CITY OF PORT WENTWORTH

PLANNING COMMISSION

JUNE 11, 2018

Site Plan Review Application submitted by Haydon Rollins, Hussey, Gay, & Bell, on behalf of CRN Development, LLC., for PIN # 7-0037-01-012 (Coldbrook Station Cir) for a Specific Development Site Plan to allow a multi-family apartment development in a P-R-M (Planned Residential Multi-Family) Zoning District

DRAWING NUMBER
06
OF 26

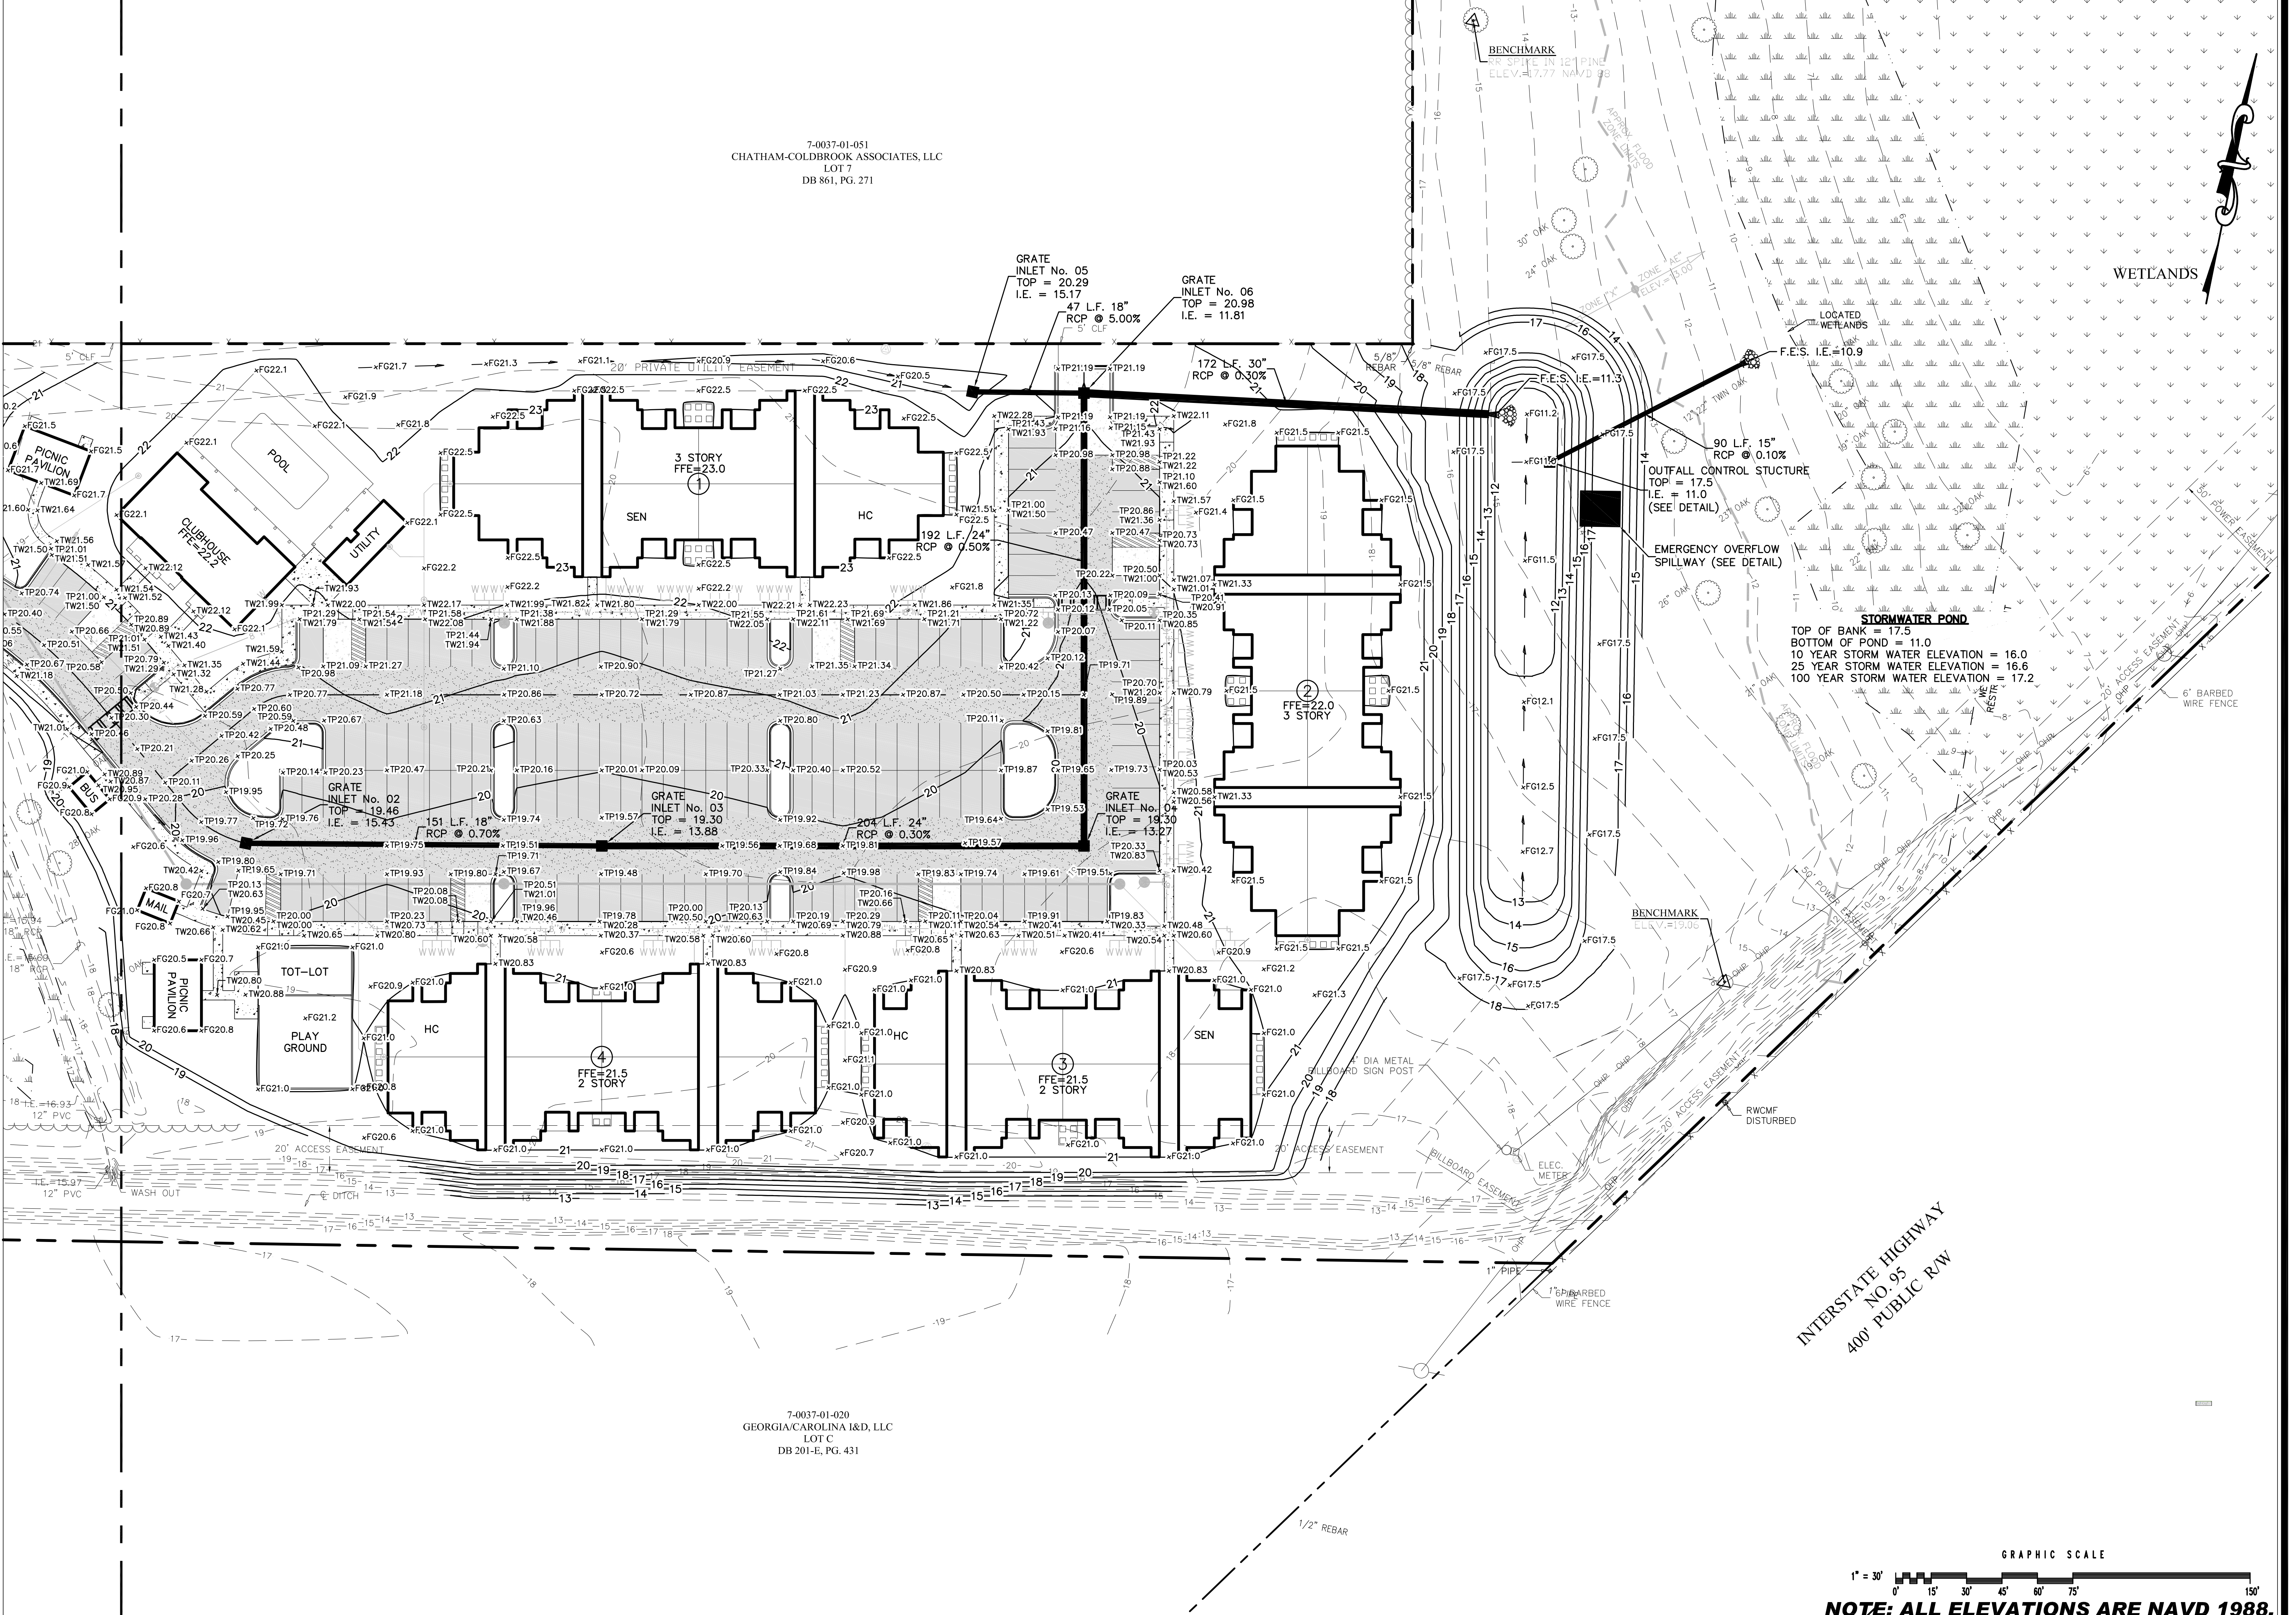
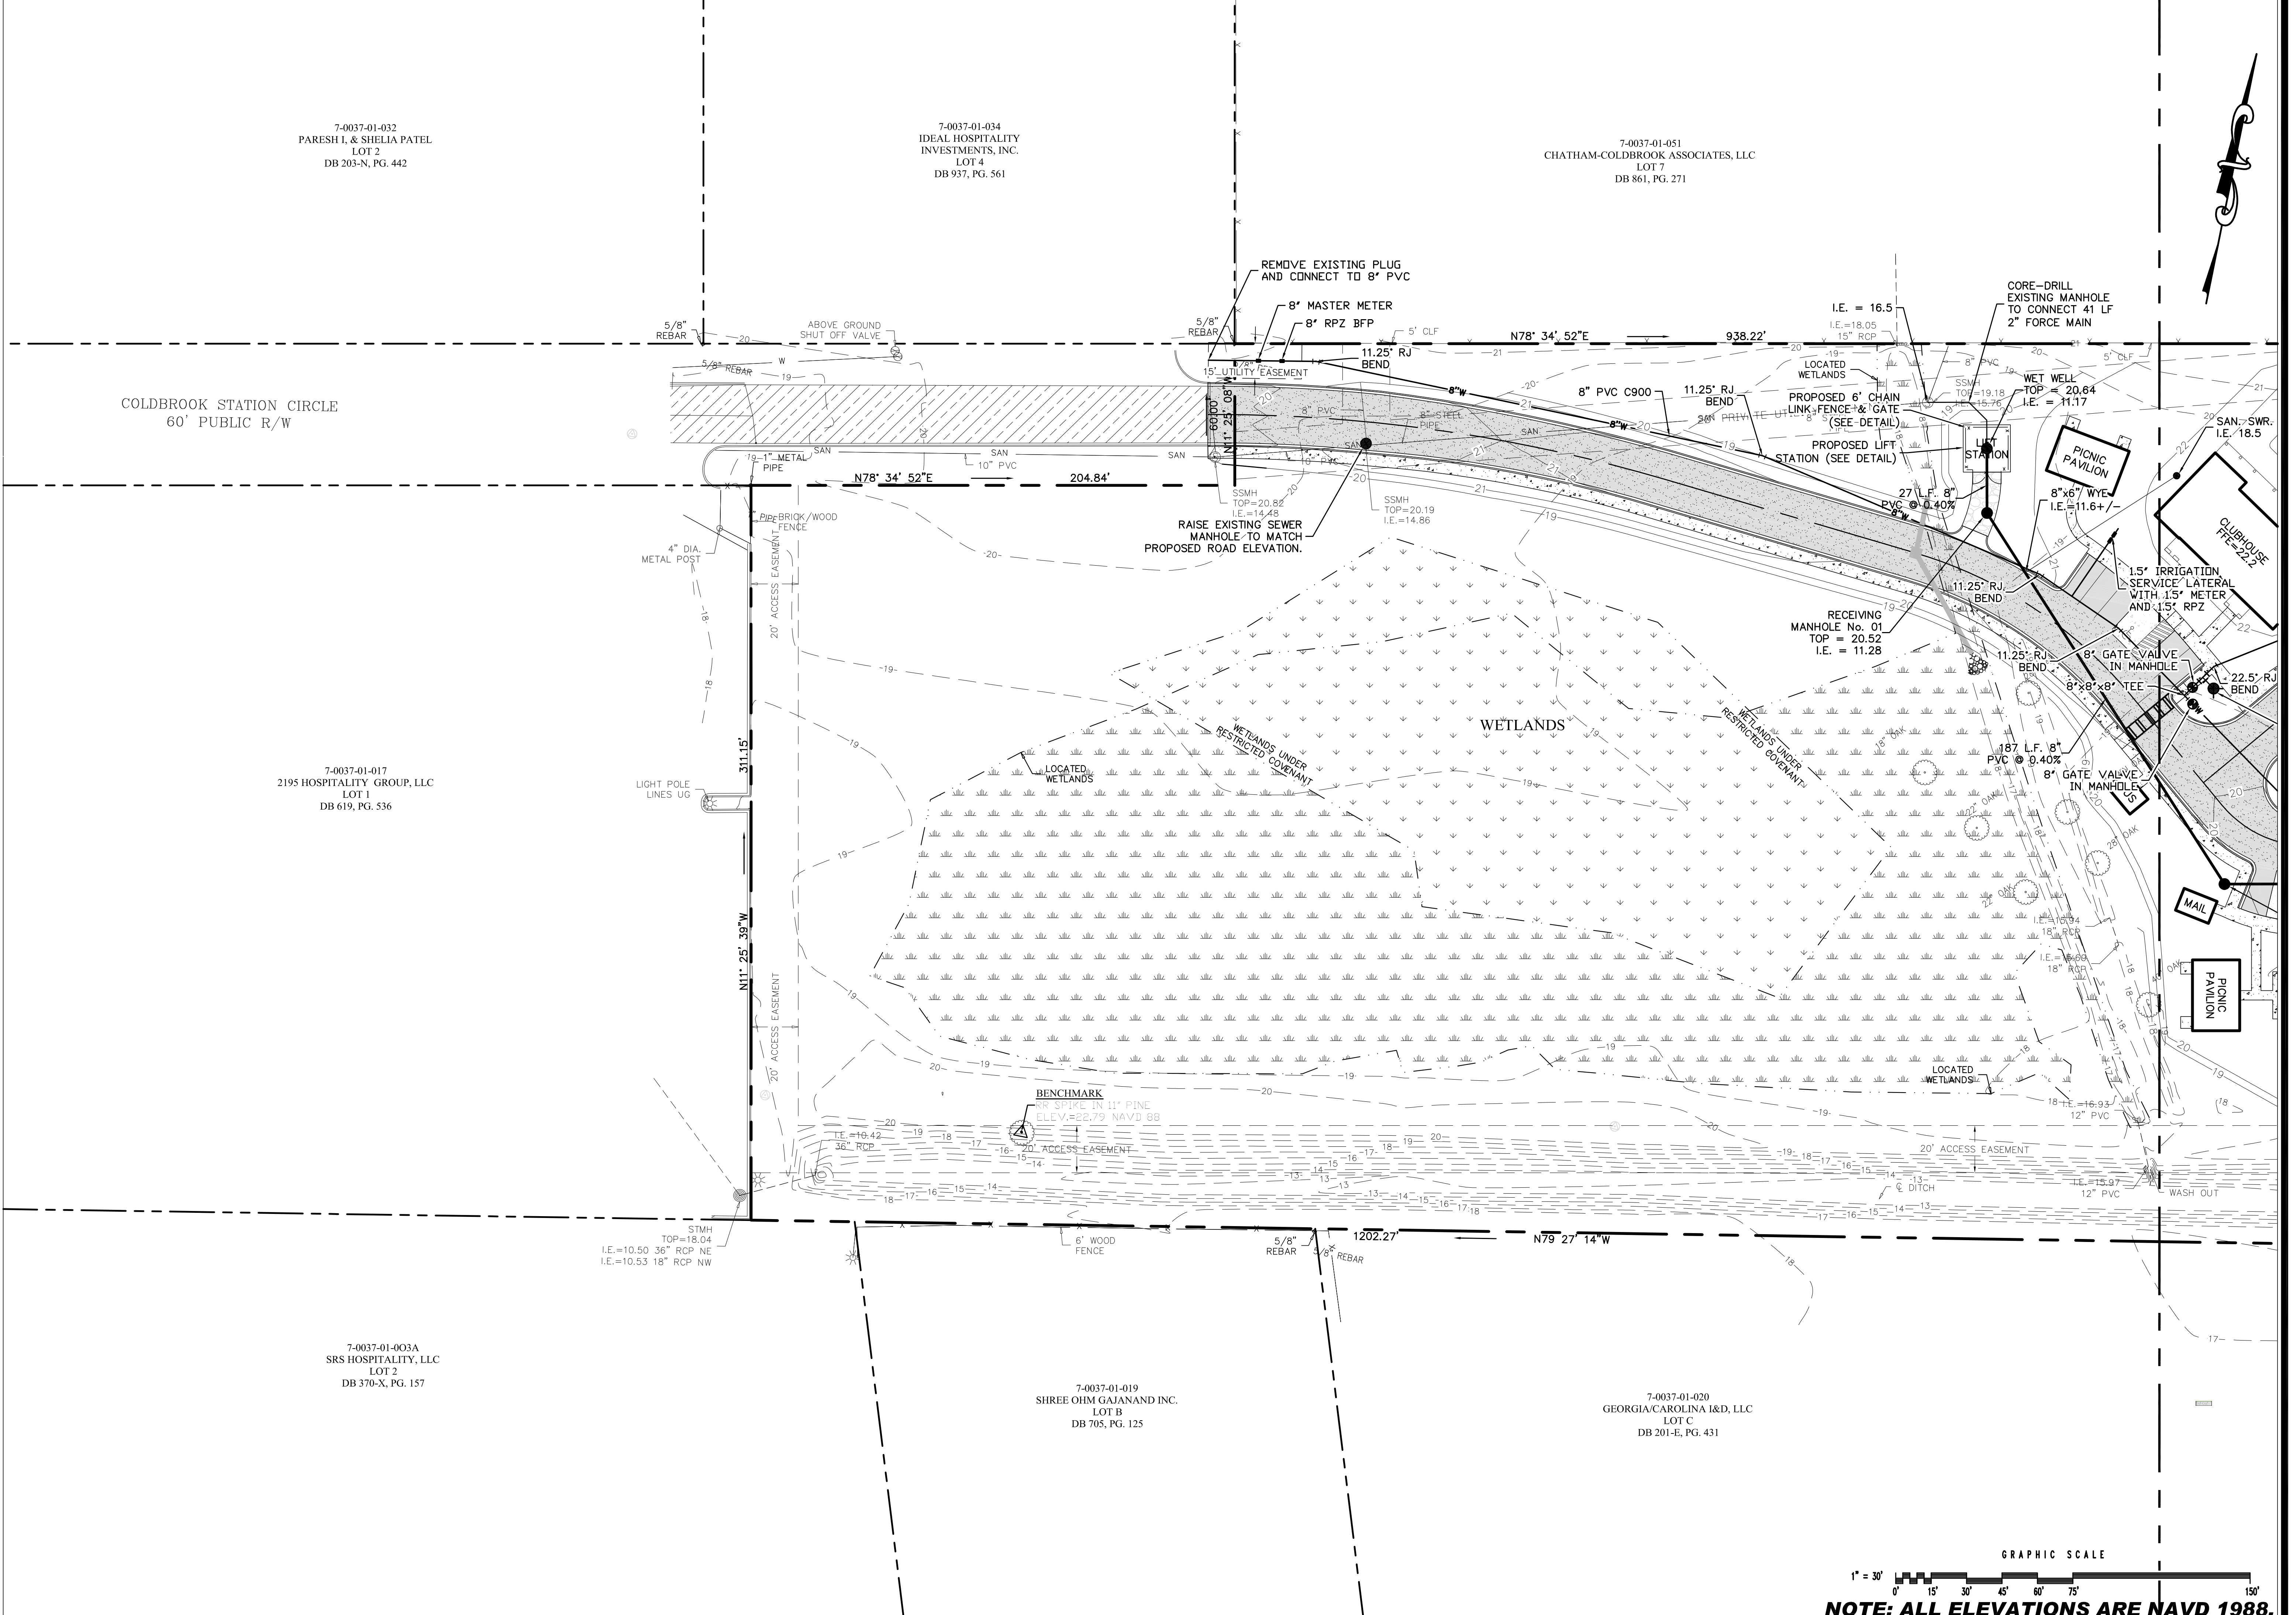
11. Match crowns on storm sewer pipes.
Acknowledged. Please see the revised plan sheets 5, 6 and 9.
12. Add storm sewer pipe profiles for G.I #5 & #6 to pond, add pond outlet pipe profile.
Acknowledged. Please see the revised plan sheet 9.

13. The grading plan sheet 07, the existing roadway section under construction is crowned thus the proposed roadway needs to match the existing section then create an appropriate transition to an inverted crown section as desired per your design.
Acknowledged. Please see the revised plan sheet 5.
